MANDATORY SERVICE BULLETIN**NUMBER:** SB11-16**REVISION:** 00**DATE:** 10/07/2011**SUBJECT:** CREW SEAT STOP BRACKET ADDITION**EFFECTIVITY:**

KODIAK 100 Series Aircraft Serial Numbers: 100-0001 through 100-0055

The accompanying Field Service Instruction provides guidance for the installation of stop brackets onto the crew seat adjustment assembly and must be complied with to prevent possible future damage to the crew seat chain plate, P/N 100-825-1231. Contact Quest Customer Service for Service Kit P/N FSI-024.

TITLE: Crew Seat Stop Bracket Addition
SERIAL RANGE: 100-0001 through 100-0055
JASC CODE: 2510

Figure 1-1: Component Removal

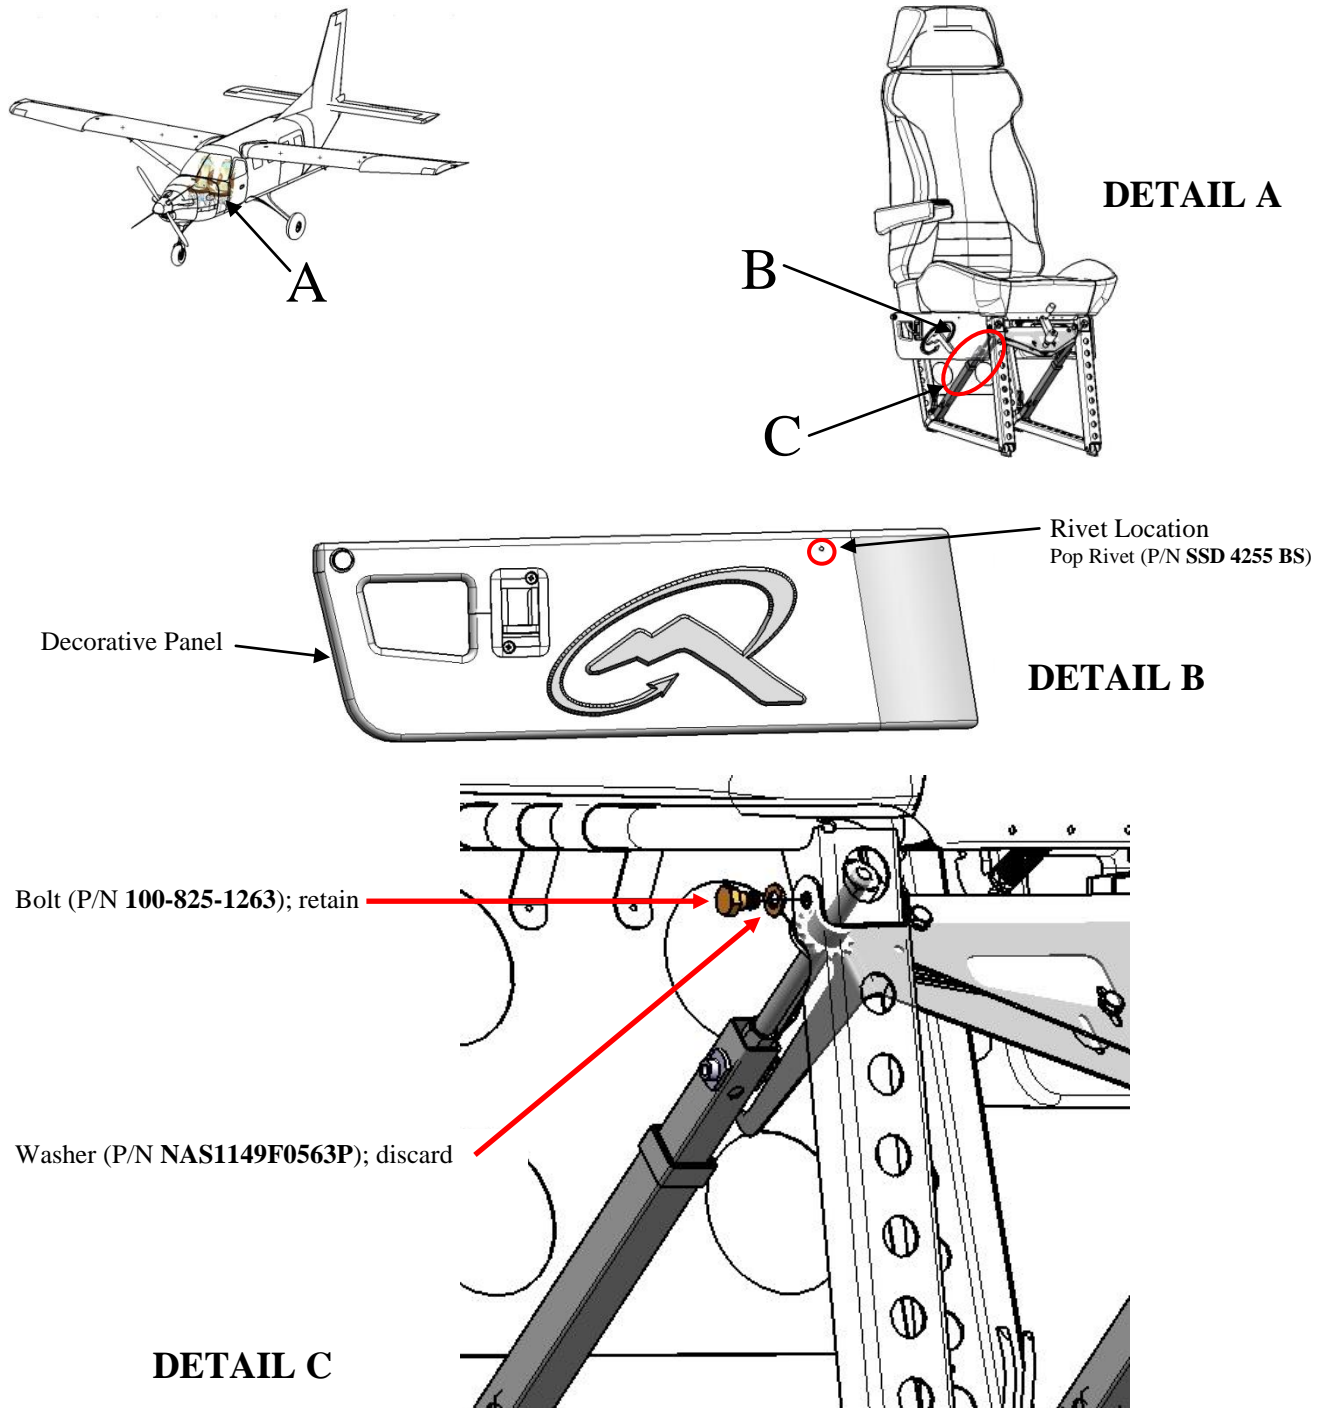
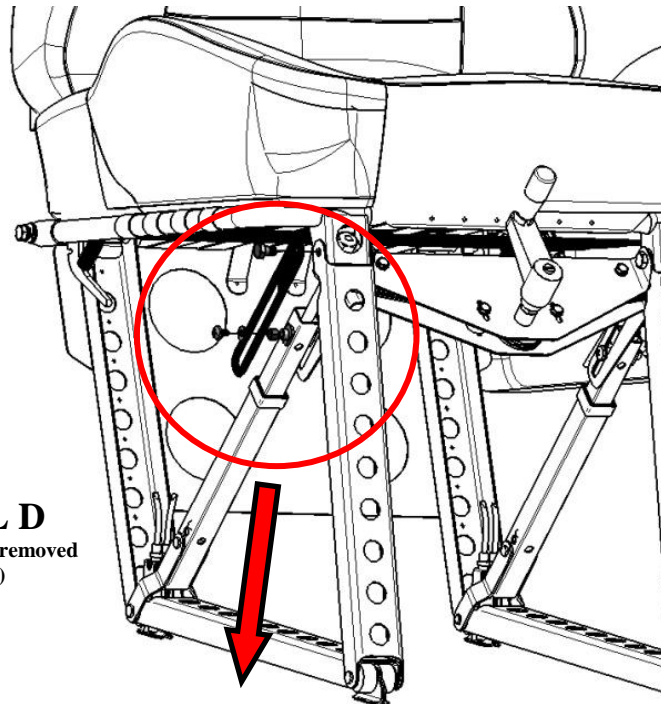
During the component removal and stop bracket installation, it is possible to pull the crew seat decorative panel aside enough to provide a sufficient working area. It is acceptable to remove the pop rivet indicated in **Figure 1-1, Detail B** to provide a larger working area. A new pop rivet (P/N **SSD 4255 BS**) will need to be installed after the installation of the stop brackets in **Section 6**. Follow all the manufacturer's installation and safety instructions.

Remove the bolt (P/N **100-825-1263**) and washer (P/N **NAS1149F0563P**) on both outboard sides of the crew seat as shown in **Figure 1-1, Detail C**. Discard the washer (P/N **NAS1149F0563P**), but retain the bolt (P/N **100-825-1263**) for use in **Section 6**.

Figure 1-2: Stop Bracket Installation

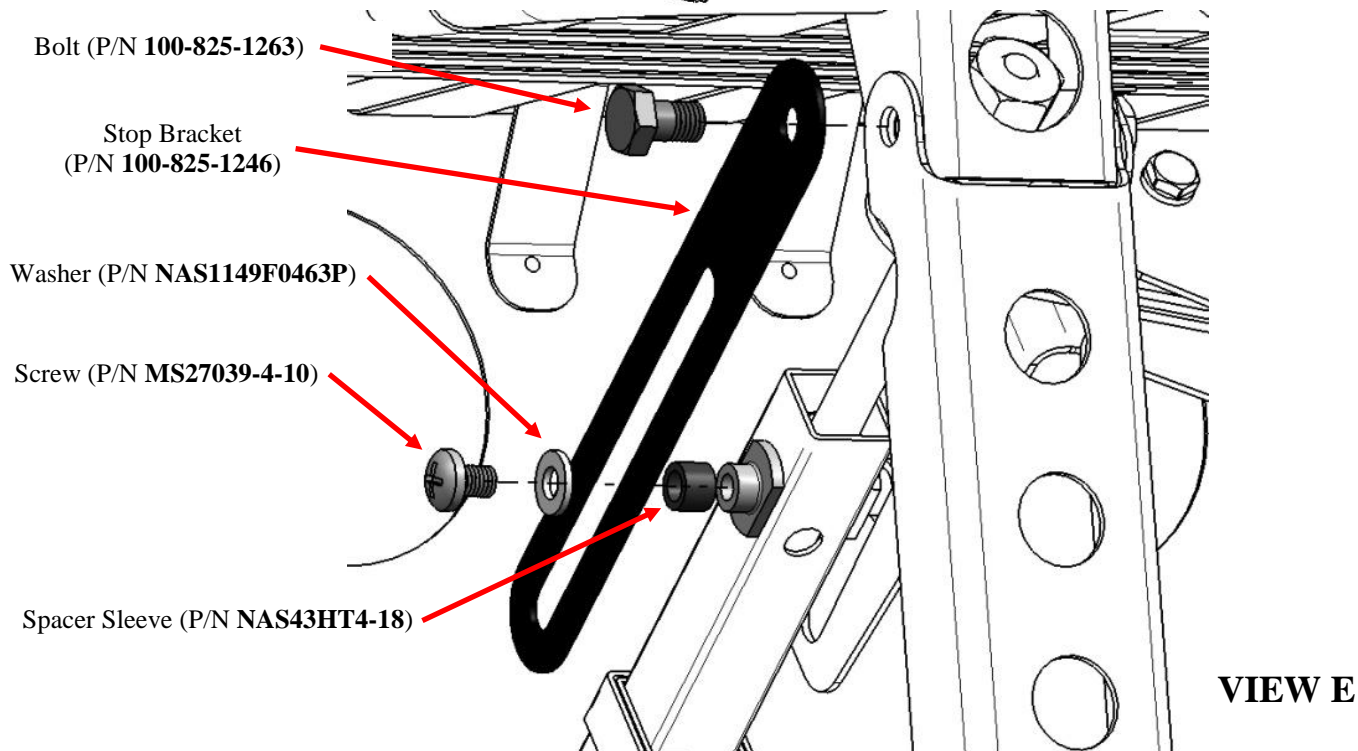
Position the stop bracket (P/N **100-825-1246**), spacer sleeve (P/N **NAS43HT4-18**), and washer (P/N **NAS1149F0463P**) securing them into position with the pan head screw (P/N **MS27039-4-10**) as shown in **Figure 1-2, View E**. Torque the pan head screw to 50-70 in-lb.

Position the stop bracket (P/N **100-825-1246**), apply Loctite® 222MS® to the bolt (P/N **100-825-1263**) threads, and secure as shown in **Figure 1-2, View E**. Torque the bolt to 65-75 in-lb.
